ADDENDUM NO. 4

DATE: July 26, 2021
FROM: City of Grand Junction Purchasing Division
TO: All Offerors
RE: 2021 Kannah Creek Flowline Replacement Construction IFB-4926-21-DH

Figure 1. Approximate Location of Stockpile Area

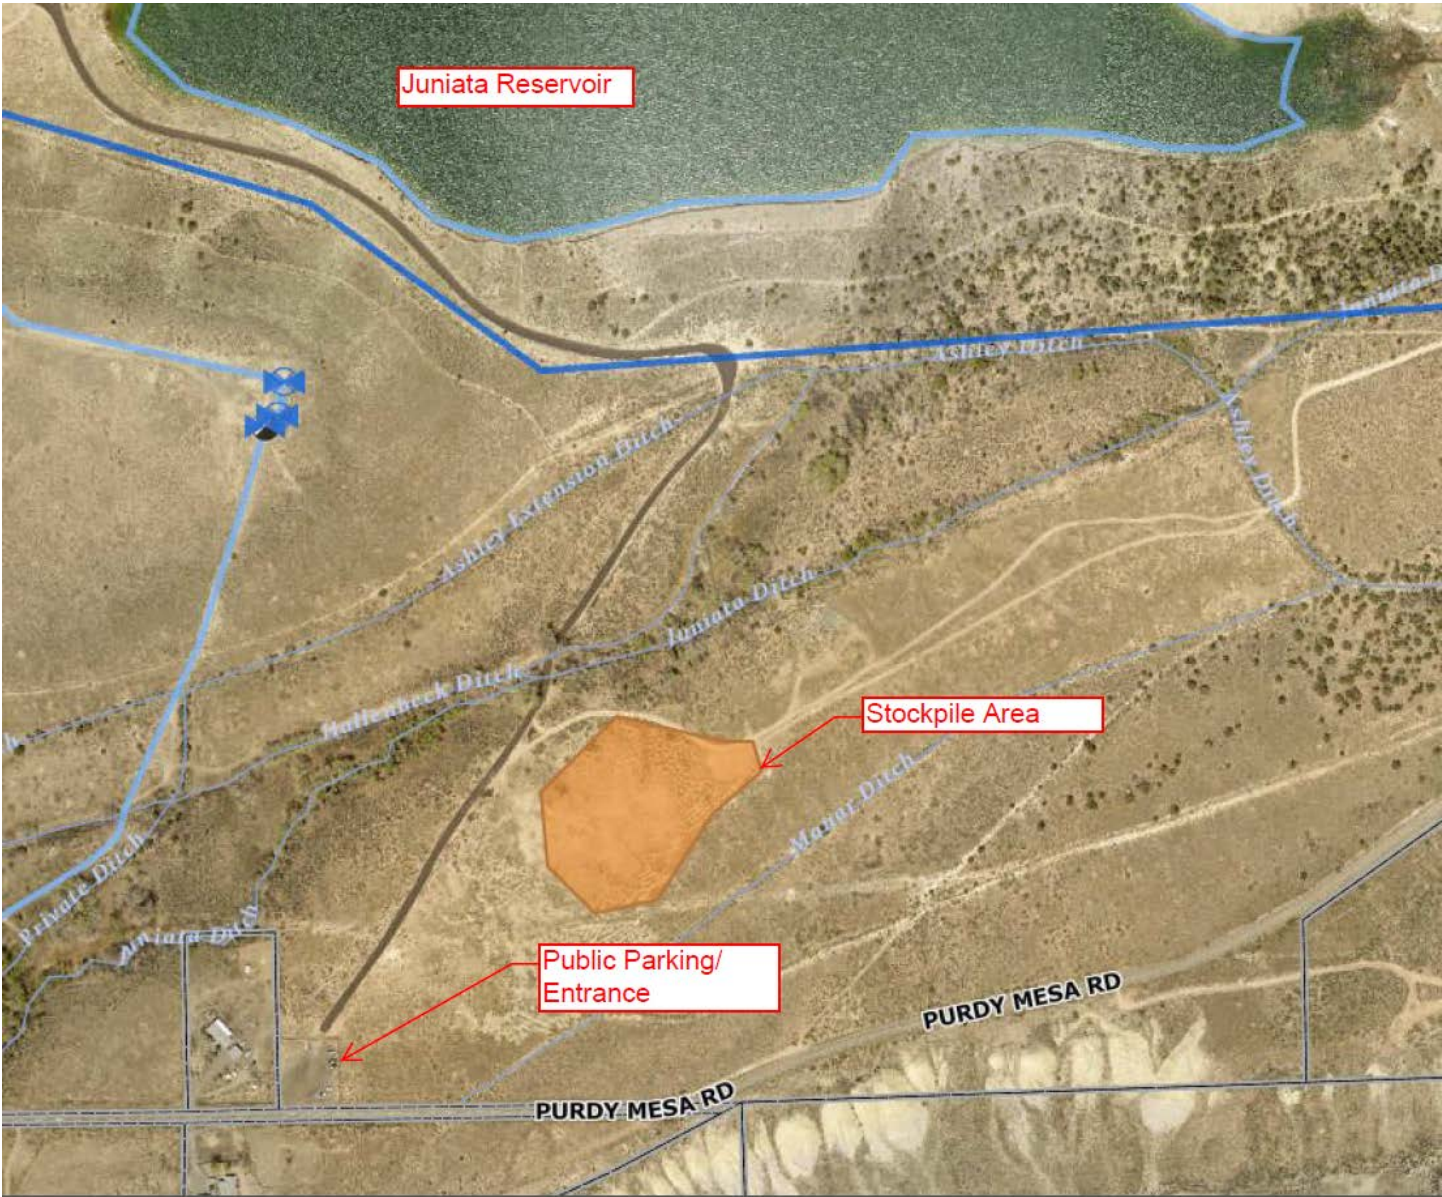
- A. See Groundwater Barrier Detail (3/C1.0).
7. Q. Will pipe spoils be allowed to be spread and left onsite within ROW prior to seeding?
- A. Spoils shall be dispersed/stockpiled at designated stockpile site as noted in the Pre-Bid meeting. See attached Figure 1 for approximate location.
